Wednesday, February 18 - PLH25-0040 The Townsite

Attn: City of Chandler, Development Services Department Planning Division

I am writing to submit comments regarding Case No. PLH24-0040 (Townsite Project) for inclusion in the project record and staff review. I live in close proximity to the project site and am also a licensed landscape architect practicing in the Valley. I currently serve on the Chandler Planning and Zoning Commission and will formally recuse myself from any involvement in this case if deemed necessary by the City. These comments are submitted solely in my capacity as a nearby resident and design professional.

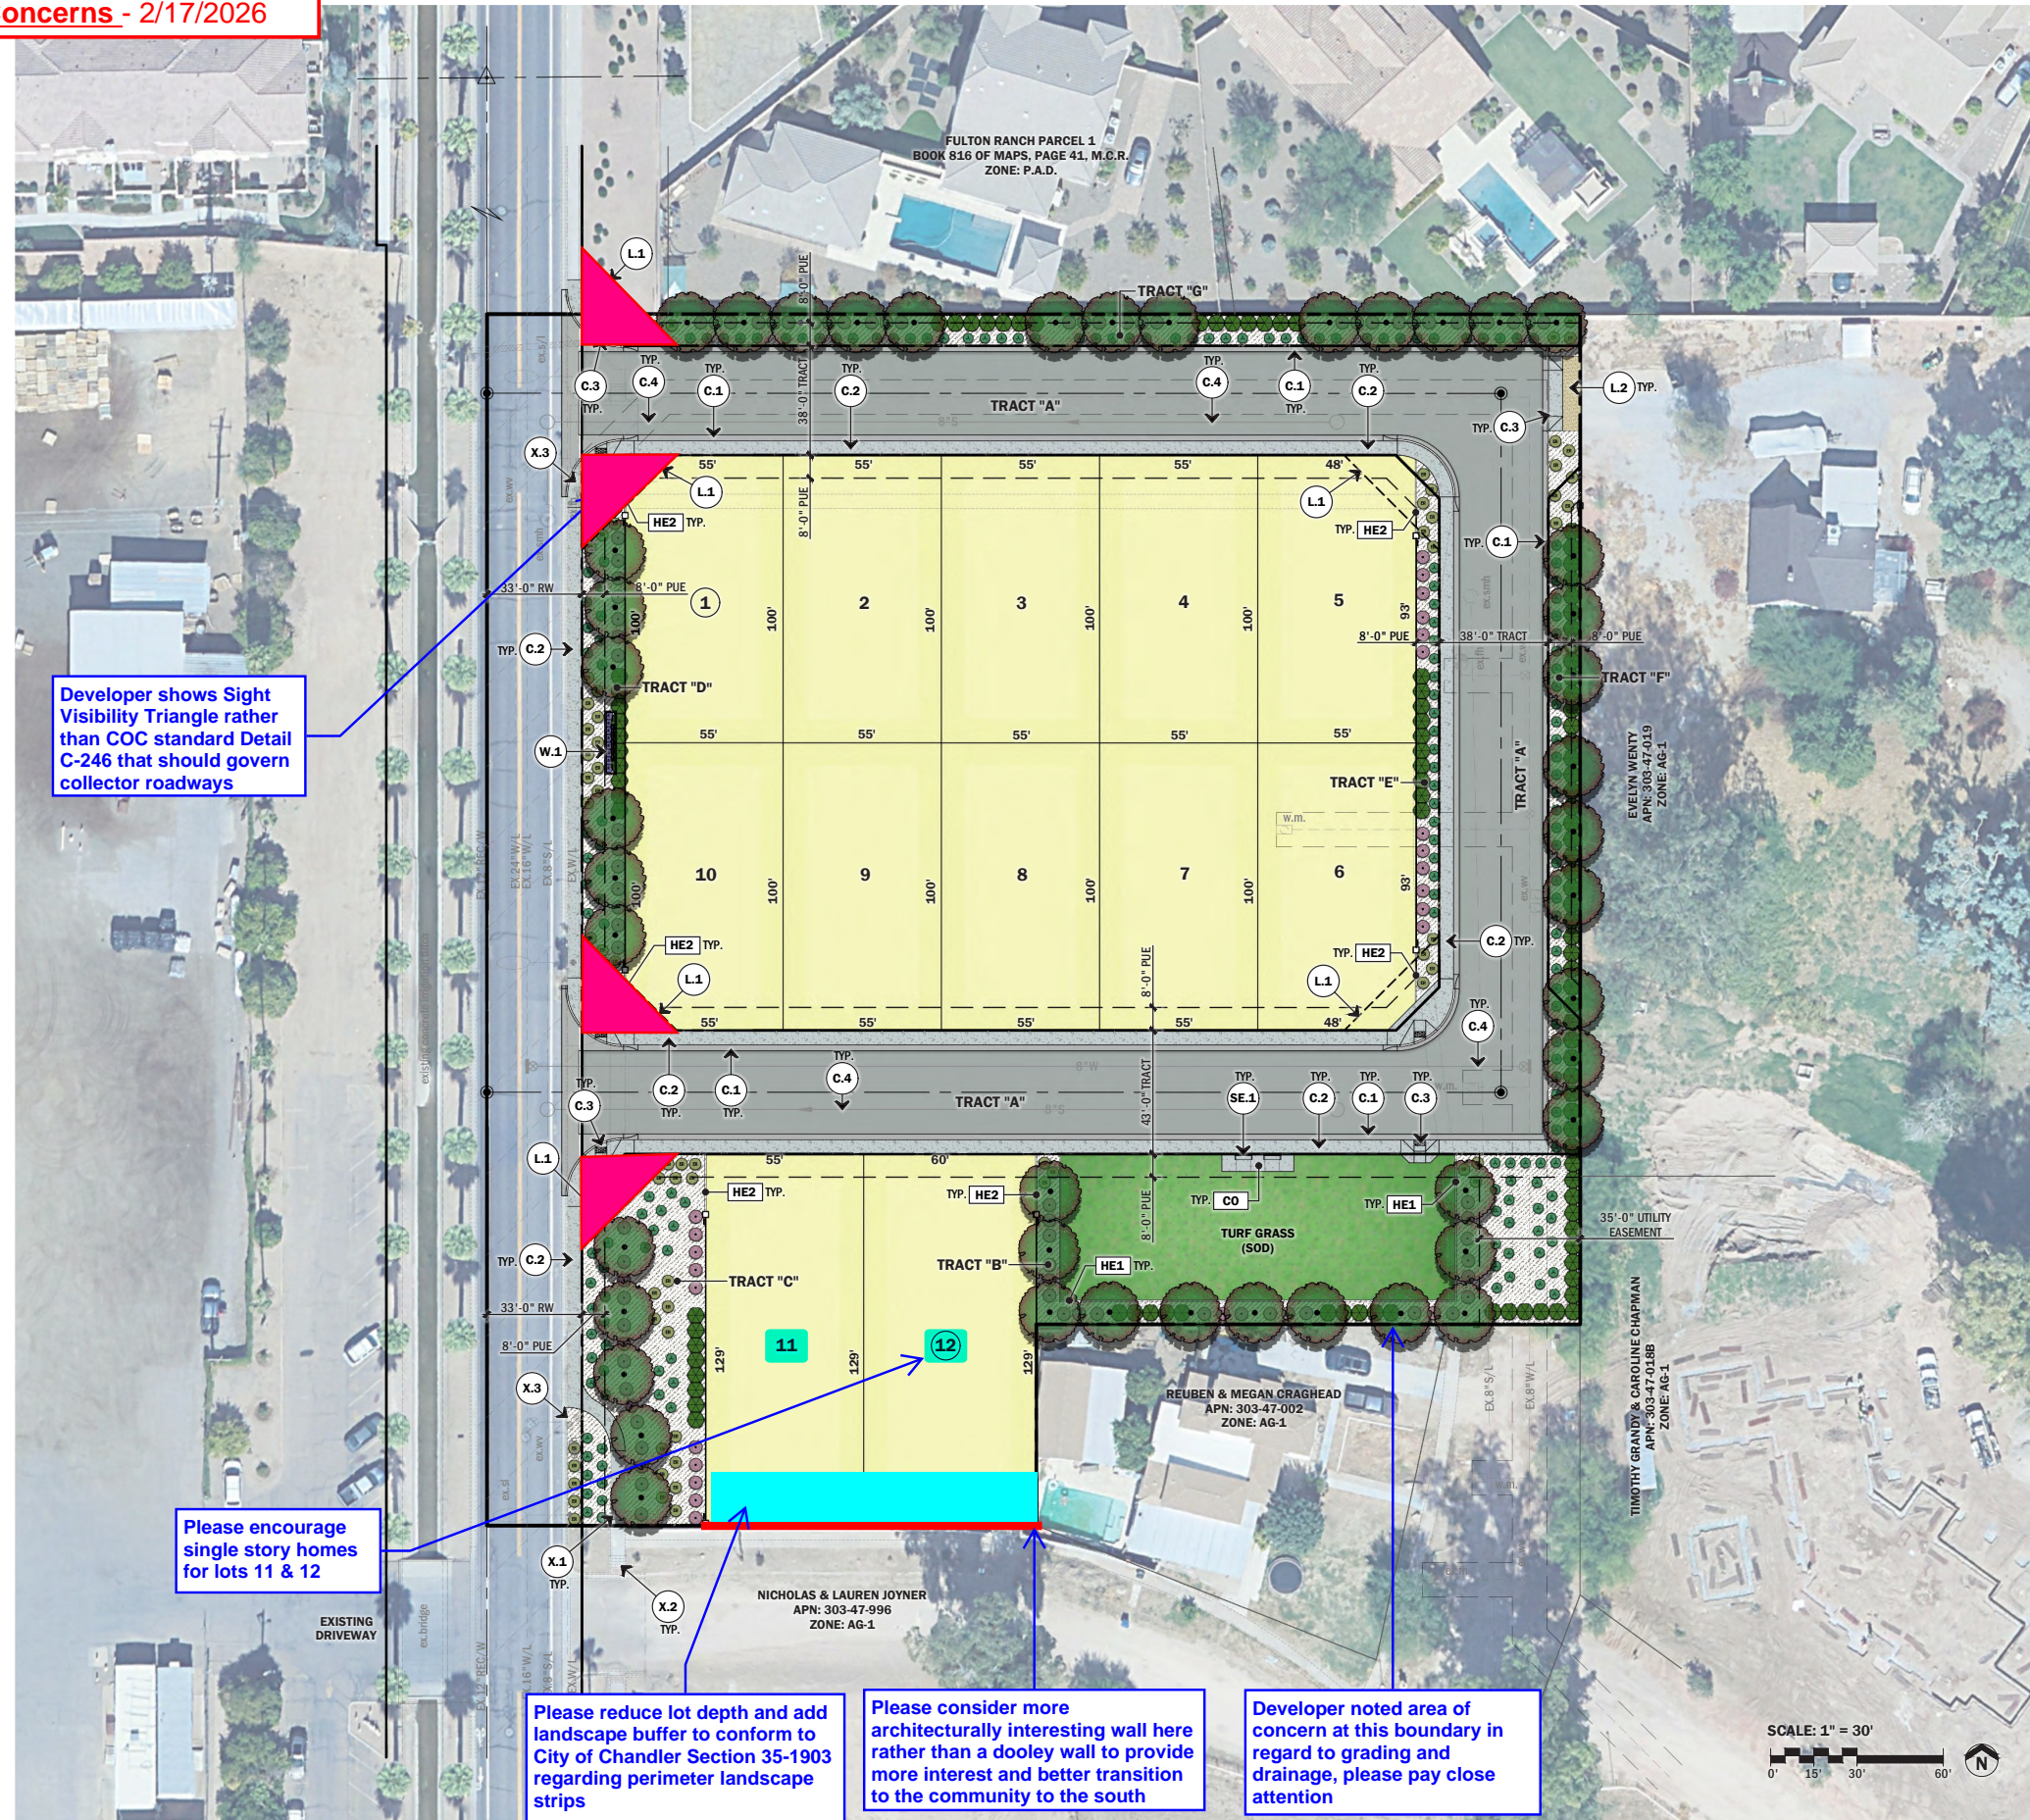
Developer shows Sight Visibility Triangle rather than COC standard Detail C-246 that should govern collector roadways

Please encourage single story homes for lots 11 & 12

Please reduce lot depth and add landscape buffer to conform to City of Chandler Section 35-1903 regarding perimeter landscape strips

Please consider more architecturally interesting wall here rather than a dooley wall to provide more interest and better transition to the community to the south

Developer noted area of concern at this boundary in regard to grading and drainage, please pay close attention
